Engineering Change Notification

Supplier Name: Heller Industries

Reactor Catalyst Upgrade And Return Gas Into Flux Box

ALPHA 2043MK7 NGBA ALL OVEN

SEC.6 – Side-by-Side Images

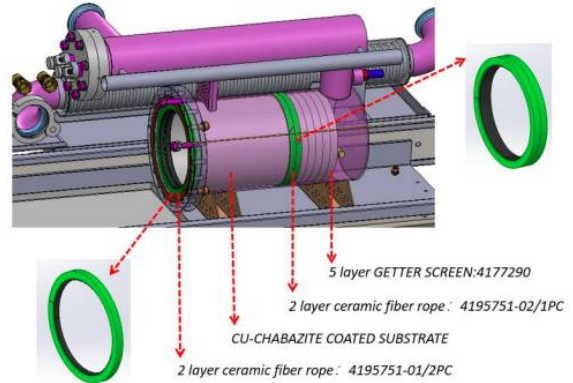
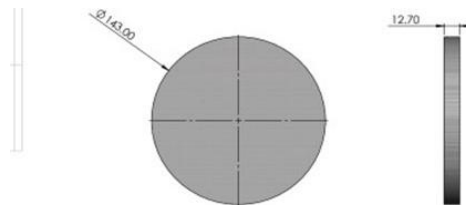
Change Item	Present Value	Proposed Value	Reason for Change
Reactor Catalyst	205019+2210186	4177290+4188290+4195751-xx	Improve and enhance flux collection efficiency to make the oven chamber cleaner
Return Gas Into Flux Box	205000 (Bottom Exhaust ,reactor)	4190980 (Update KIT)	Improve and enhance flux collection efficiency to make the oven chamber cleaner

1. Reactor Catalyst Upgrade
2. Reactor return Gas from bottom PLD change to Large Flux box .

New catalytic design shown

The GPF ceramic filter technology must first be wrapped with aluminum foil. 3-5 perimeter wrap layers is suggested. However, if more Aluminum wrap can be accommodated, that would help prevent by-pass. Please proceed.

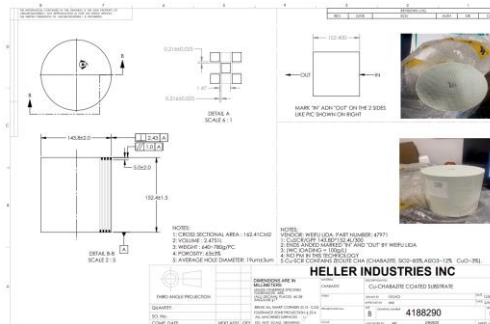
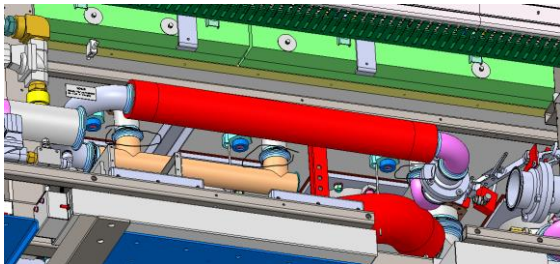
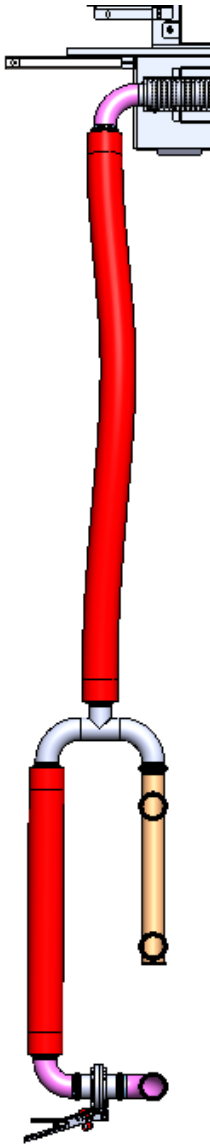
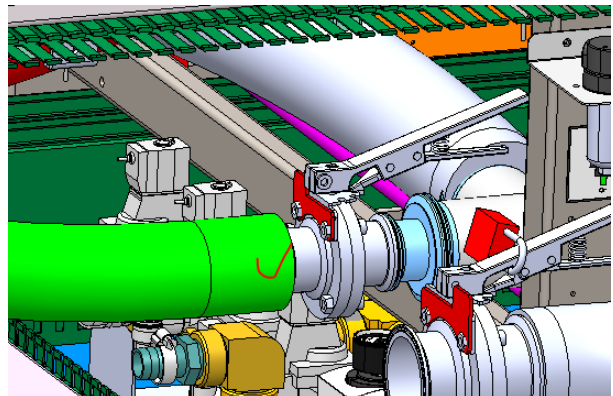
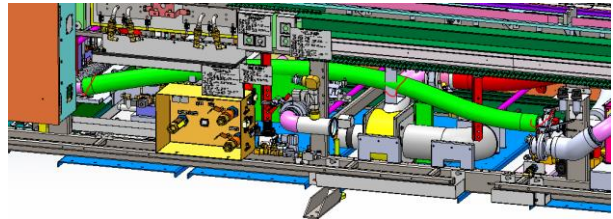
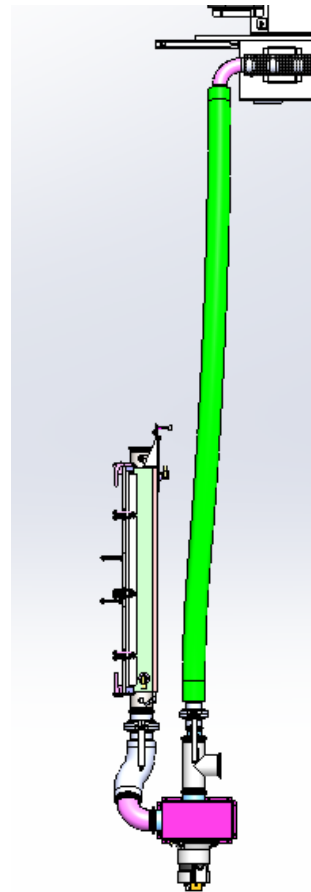
- Remove old reactor catalyst from oven
- Add new reactor catalyst to oven
- Update reactor return Gas tube from bottom PLD to Large Flux box
- Heating oven for testing
